PEAK GYMNASTICS

EL PASO COUNTY, STATE OF COLORADO  
GRADING & EROSION CONTROL PLAN

LOTS 9 & 10 OF ROLLING THUNDER BUSINESS PARK FIL. NO. 1

GRADING & EROSION CONTROL PLAN  
PEAK GYMNASTICS  
JOB NO. 44-032  
DATE PREPARED: MAY 30, 2018  
DATE REVISED:

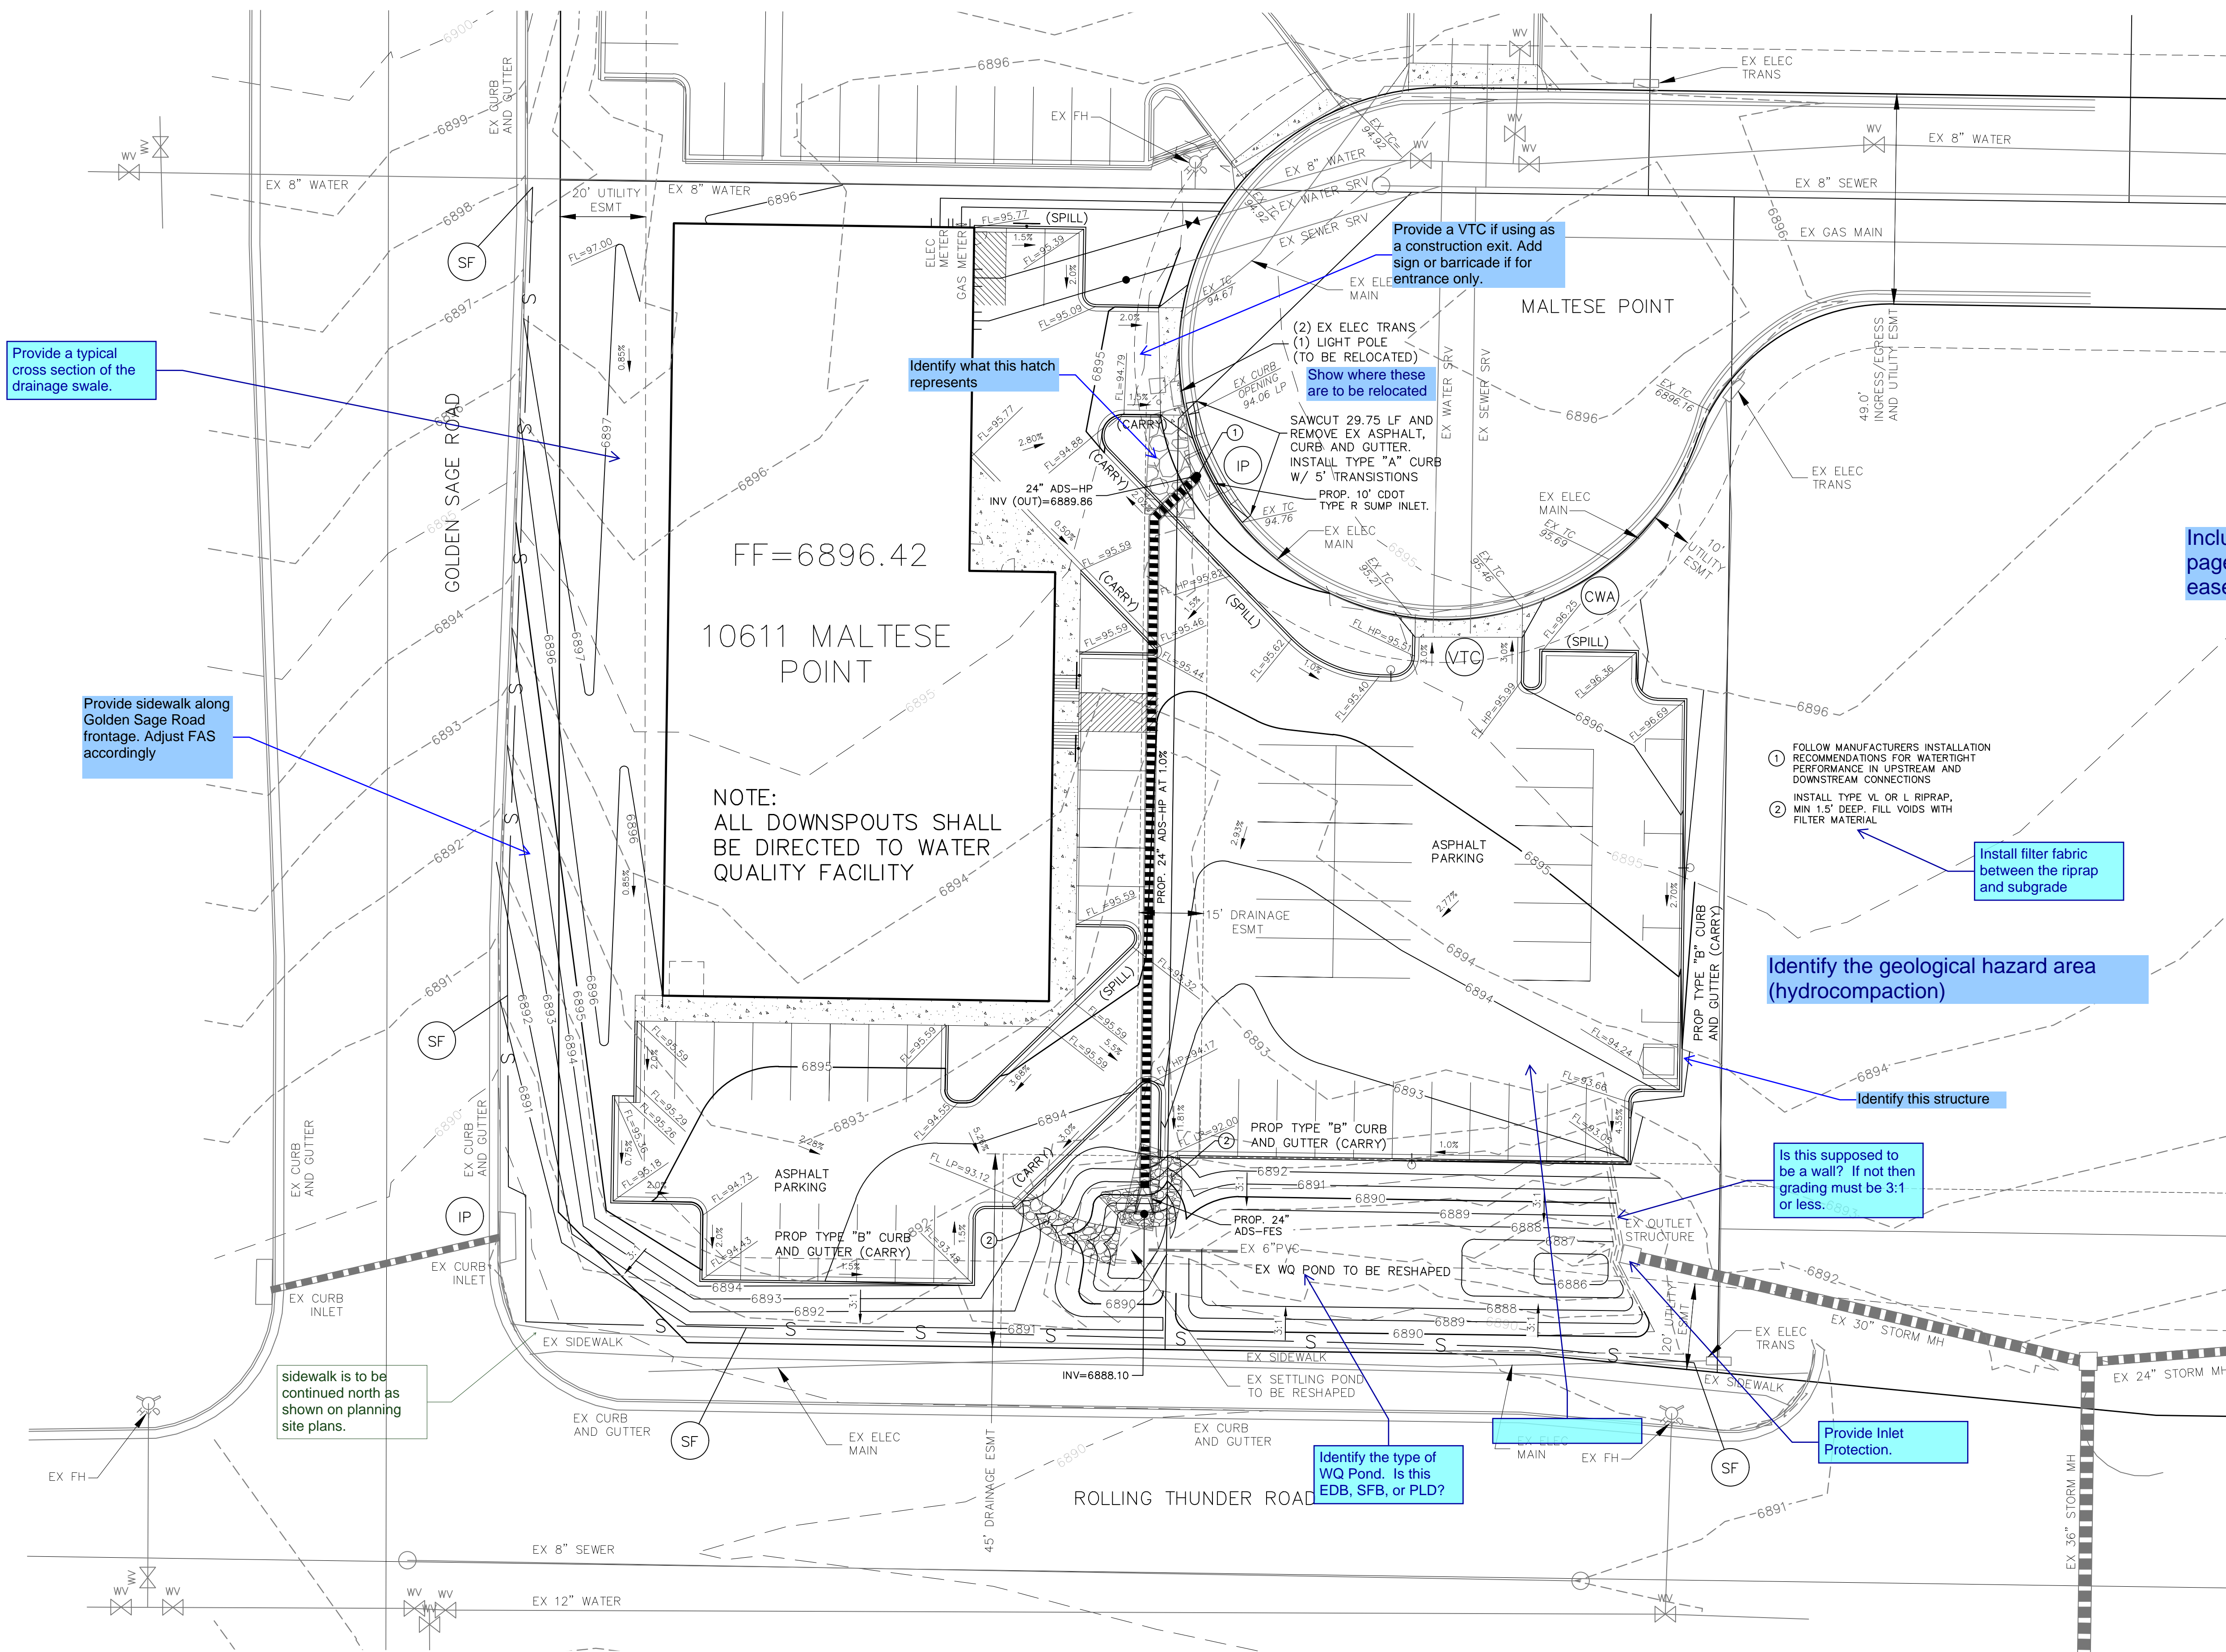
Identify limits of construction  
and limits of disturbance

Include the book and  
page numbers for all  
easements

Provide a typical  
cross section of the  
drainage swale.

Provide sidewalk along  
Golden Sage Road  
frontage. Adjust FAS  
accordingly

sidewalk is to be  
continued north as  
shown on planning  
site plans.

Identify what this hatch  
represents

Provide a VTC if using as  
a construction exit. Add  
sign or barricade if for  
entrance only.

Show where these  
are to be relocated

Install filter fabric  
between the riprap  
and subgrade

Identify the geological hazard area  
(hydrocompaction)

Identify this structure

Is this supposed to  
be a wall? If not then  
grading must be 3:1  
or less.

Identify the type of  
WQ Pond. Is this  
EDB, SFB, or PLD?

Provide Inlet  
Protection.
